Access Compliance Report Public Rights-of-Way (Curb Ramps)

Intersection ID: 53927 Main Street: PRESTON_KNOLL_LN Cross Street: BRITTONDALE_LN Location: N

ADA ID: 77C124E2C722 Ramp Type: PerpDiag Initial Pass/Fail: Fail Overall Compliance: No Severity Score: 10

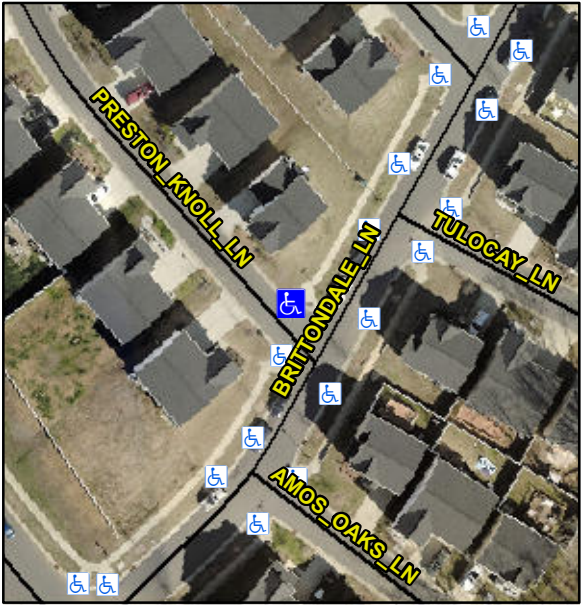
PROW/ADA:
Not Found, R304.5.1, R304.5.3

Compliance	Description	Data	Compliance	Description	Data
N/A	Ramp Length (in)	104.0	Yes	Ramp Slope (%)	5.4
No	Ramp Width (in)	47.0	No	Ramp XSlope (%)	2.1
N/A	Flare Type LT	N/A	N/A	Flare Type RT	N/A
N/A	Flare Slope LT (%)	N/A	N/A	Flare Slope RT (%)	N/A
N/A	Flare Traversable LT?	N/A	N/A	Flare Traversable RT?	N/A
N/A	Landing Length (in)	N/A	N/A	DWS Provided?	N/A
N/A	Landing Width (in)	N/A	N/A	DWS Contrast?	N/A
N/A	Landing Slope (%)	N/A	N/A	DWS Length (in)	N/A
N/A	Landing X Slope (%)	N/A	N/A	DWS Full Width?	N/A
N/A	Landing Curb? (Y/N)	N/A	N/A	DWS Offset (in)	N/A
N/A	Shared Landing?	N/A			
N/A	Gutter Ponding?	N/A	N/A	Gutter Slope (%)	N/A
N/A	Gutter Lip Ht (in)	N/A	N/A	Gutter X Slope (%)	N/A
N/A	Painted X Walk1?	No	N/A	Painted X Walk2?	No
	X Walk 1 Direction	To SW		X Walk 2 Direction	To SE
N/A	X Walk 1 Width (in)	N/A	N/A	X Walk 2 Width (in)	N/A
	X Walk 1 Slope (%)	3.0		X Walk 2 Slope (%)	6.7
	X Walk 1 X Slope (%)	4.1		X Walk 2 X Slope (%)	3.6

Possible Solutions:
Remove & Replace Curb Ramp With Two New Directional Ramps or Equivalent.
